Memo to: Darren Ding, Planner II – Development
From: Taylor Posey, Planner II – Parks
File Number(s): ZBLA-25-0004, SUB-25-0002 and CON-25-0003
Location: 114 Centre Street West
Applicant: David Frattaroli

Materials reviewed:

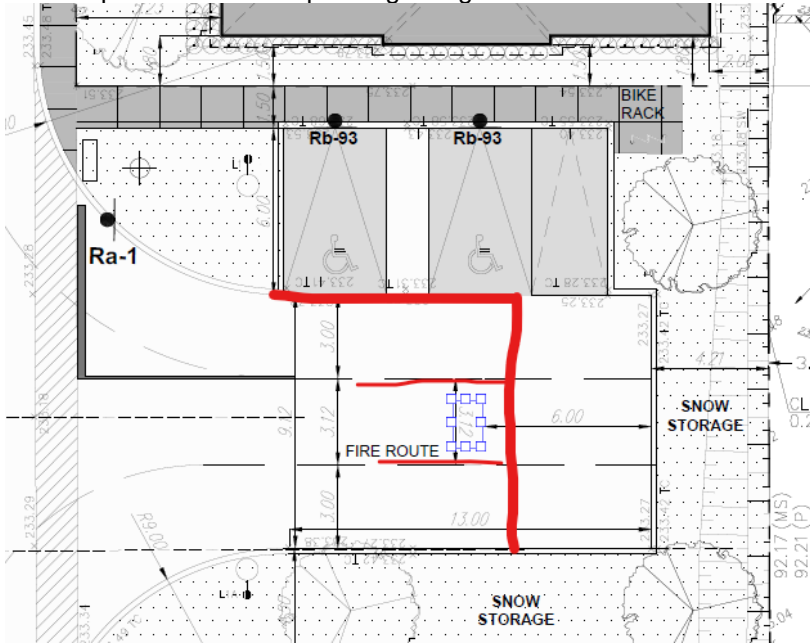
7. Silt fencing must not encroach into the tree protection fencing. Please ensure it is located outside of the tree protection fencing.
8. Ensure proposed landscaping does not conflict with proposed servicing.
9. The parking and laneway area (see below) is taking up a large portion of the proposal. Staff request this area is revised to reduce the amount of hardscaping it is contributing and trees that are required to be removed. The applicant could shorten this dead-end laneway and put the parking at its terminus to allow for tree preservation and planting along the eastern side.
